COMMENTOR	COMMENTS
Crouch End Neighbourhood Forum 19c Elder Avenue Neither supports nor objects (Request for Information)	<p>With reference to the revisions posted August 30th, the updated Application Cover Letter, and the existing Red Line of the Site.</p> <p>A new feature, a bike store, has appeared in the small space alongside the western edge of the eastern annex (telephone exchange building). This is at the rear of no.11 Weston Park.</p> <p>On drawing PX352 this change is described as -</p> <p>"(6). Bike store relocated due to reconfiguration of Broadway Mews."</p> <p>However, this space is not identified as part of the red line of the site (drawing PX201), nor has it featured in previous plans.</p> <p>Does this represent a change in the site area? If so, further revisions to the application should be presented and drawings and descriptions updated. Or is it a separate development off site?</p> <p>It may be useful to have confirmed whether the ownership, permissions, or availability of this small parcel of land has been secured.</p>

Crouch End Neighbourhood Forum 02.10.2017	<p>The Crouch End Neighbourhood Forum (CENF) is a statutory body concerned with neighbourhood developme

HTH east wing rear elevation

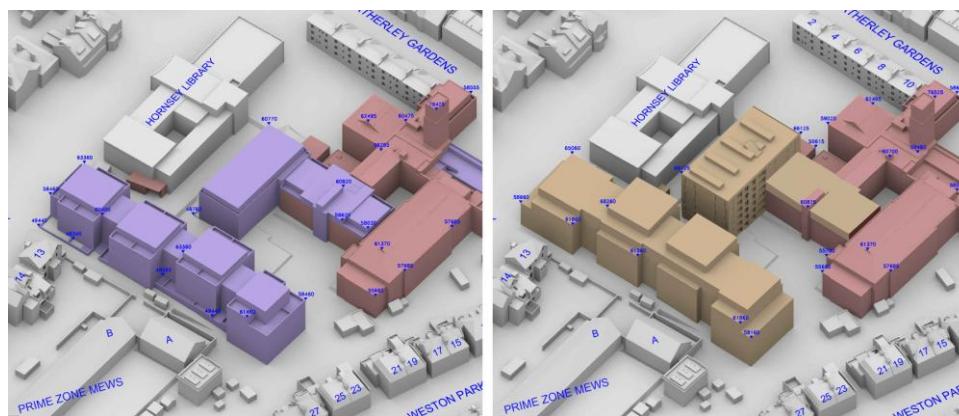
The high density of the residential development threatens to overcrowd, overshadow and dominate the heritage assets, which experience harm through the scale and bulk of the new blocks. We are concerned with the form of Block B. This block physically adjoins the east wing of the Town Hall, and is sited within metres of the Library. The junction between Block B and the east wing cannot be seen in the applicant's presentation, and it is difficult to read how details of fenestration and difference in floor levels are articulated visually. We strongly disagree that the rear elevations of the Town Hall have little architectural merit, as they present a considered symmetry balancing the important projecting east wing glazed stairwell (as in image below).

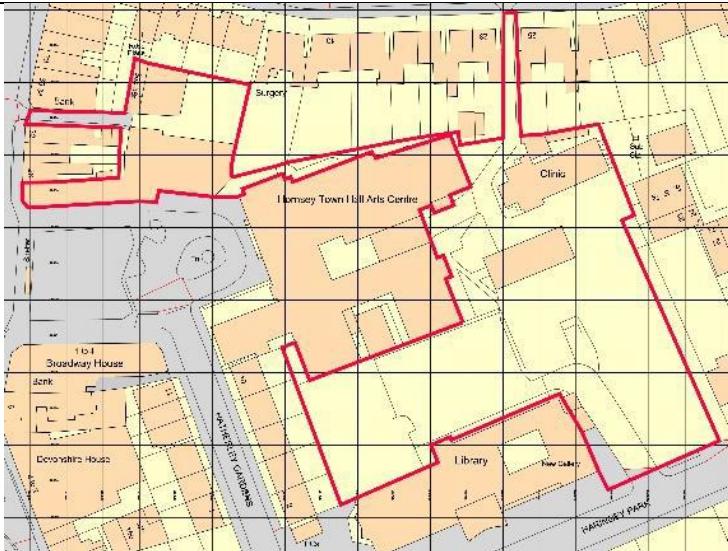
The developers have included the Town Hall 'square' as developable site area for calculation of density, inflating the available site area and decreasing the actual density. The Town Hall 'square' should not be included in the overall site area for calculation purposes; it is a public space, which by the Council's own criteria is dedicated to Community, was never intended to be built upon and whose inclusion in the site area calculation serves only to dilute the scheme's real density. Similarly, the inclusion of the Town Hall itself, when this area is not part of the application for residential construction, should not be included in the calculations.

The diagram below shows the site area that should be used for calculation of density – removing the Town Hall Square and Town Hall and Hotel (or apart hotel). The relevant area is outlined in red, (although we are concerned by the inclusion of Rose Place in the Developer's proposals and calculations)

3D MODELLING TO SHOW RELATIVE SCALE AND OVERSHADOWING. To the best of our knowledge these are to scale but we wish to see the same interactive model produced by the applicant

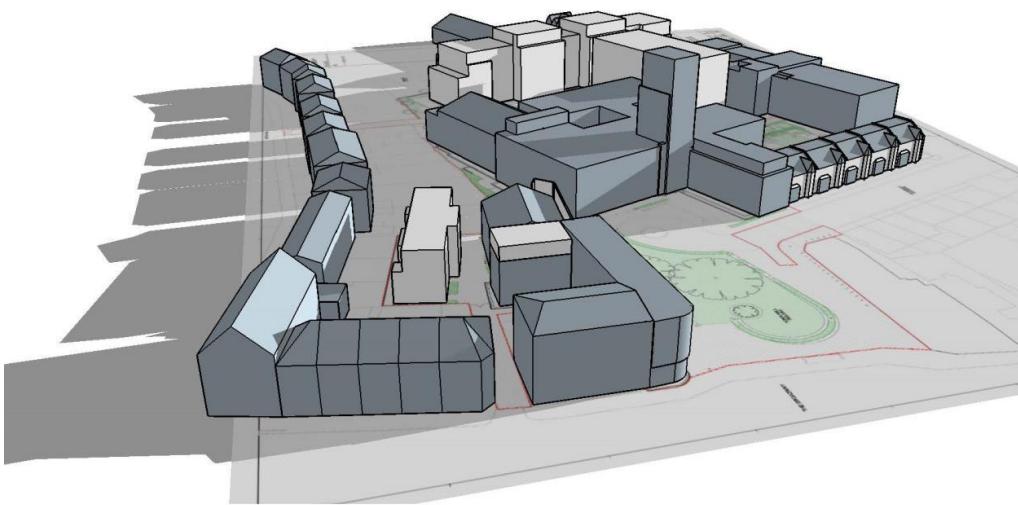
We believe this scheme flaunts good practice guidelines in relation to overshadowing of its neighbour's amenity spaces and in relation to daylight and sunlight across the development. We have done our own 3D modelling to show this, attached at the end of this letter. We want the applicant to provide all year round accurate 3D daylight modelling for the site and surrounding streets, to show the effect of overshadowing throughout the year.

View showing Hatherley Gardens with the new flats looming behind

NORTH ELEVATION 2010 scheme with outline of current proposal, in red

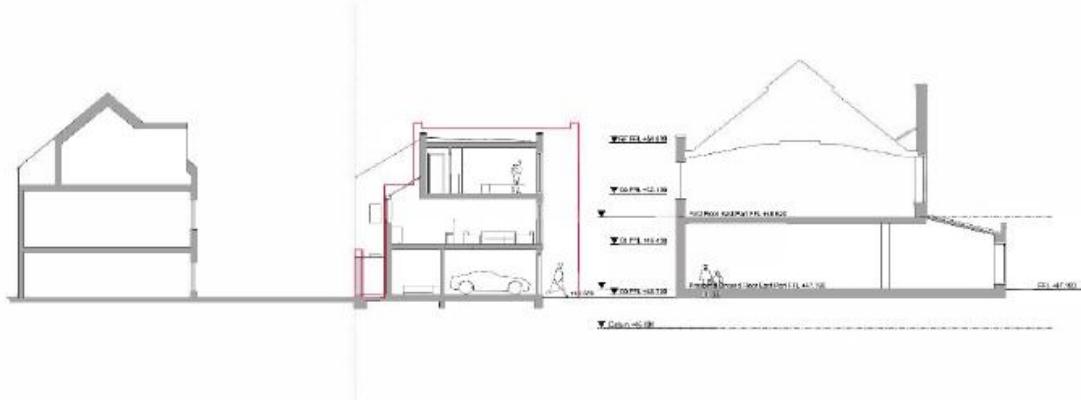
The response document refers to Block A being ‘set back’ from Haringey Park; this ignores the fact that the block projects some way in front of No.13 Haringey Park and that it is only this projecting element that is 3 storey. Behind this, as it rises to 5-storeys, it obscures the Library building when viewed from Haringey Park. Its remaining bulk looms over the rear gardens of Haringey Park dwellings in a manner completely out of character with the conservation area.

This is without reference to the block's overall mass completely dominating the Primezone mews development, of which the smaller building sits just a few metres away. We would remind the Council of its planning guidance in Policy DM3 – current until the latest iteration of the Development Management DPD, adopted 2017 – whereby 20m was the required distance between habitable windows facing each other. For every increase in floor level, a further 10m set-back was required.
